Access Compliance Report

Public Rights-of-Way

(Curb Ramps)

Intersection ID: 14403	Main Street: ALBEMARLE_RD	Cross Street: ORCHARD_RIDGE_DR	Location: SW
ADA ID: 643CAFFBA3F4	Ramp Type: Perp	Initial Pass/Fail: Fail	Overall Compliance: No
Severity Score: 13.75			
Codes/Mitigation Info/Possible Solution		Field Measurements/Component Compliance

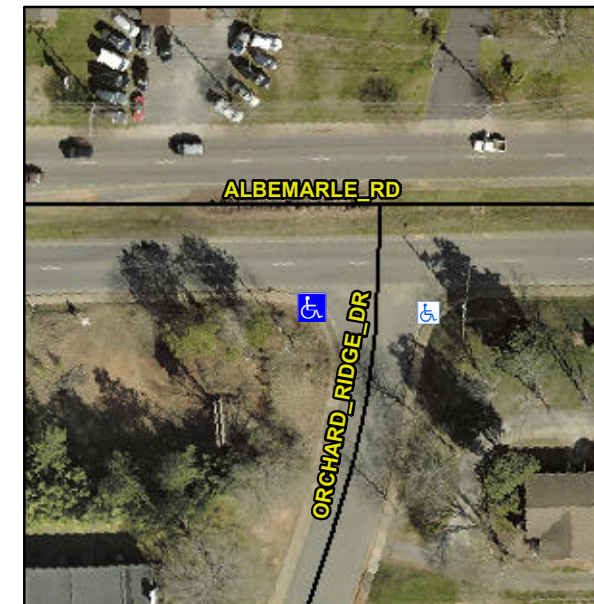
Not Found, R304.2.2, R304.5.3

Compliance	Description	Data	Compliance	Description	Data
N/A	Ramp Length (in)	60.0	No	Ramp Slope (%)	8.5
Yes	Ramp Width (in)	48.0	No	Ramp XSlope (%)	3.4
N/A	Flare Type LT	N/A	N/A	Flare Type RT	N/A
N/A	Flare Slope LT (%)	N/A	N/A	Flare Slope RT (%)	N/A
N/A	Flare Traversable LT?	N/A	N/A	Flare Traversable RT?	N/A
N/A	Landing Length (in)	N/A	N/A	DWS Provided?	N/A
N/A	Landing Width (in)	N/A	N/A	DWS Contrast?	N/A
N/A	Landing Slope (%)	N/A	N/A	DWS Length (in)	N/A
N/A	Landing X Slope (%)	N/A	N/A	DWS Full Width?	N/A
N/A	Landing Curb? (Y/N)	N/A	N/A	DWS Offset (in)	N/A
N/A	Shared Landing?	N/A			
N/A	Gutter Ponding?	N/A	N/A	Gutter Slope (%)	N/A
N/A	Gutter Lip Ht (in)	1.0	N/A	Gutter X Slope (%)	N/A
N/A	Painted X Walk1?	No	N/A	Painted X Walk2?	N/A
	X Walk 1 Direction	To E		X Walk 2 Direction	N/A
N/A	X Walk 1 Width (in)	N/A	N/A	X Walk 2 Width (in)	N/A
	X Walk 1 Slope (%)	1.0		X Walk 2 Slope (%)	N/A
	X Walk 1 X Slope (%)	3.4		X Walk 2 X Slope (%)	N/A

Remove & Replace Entire Ramp.
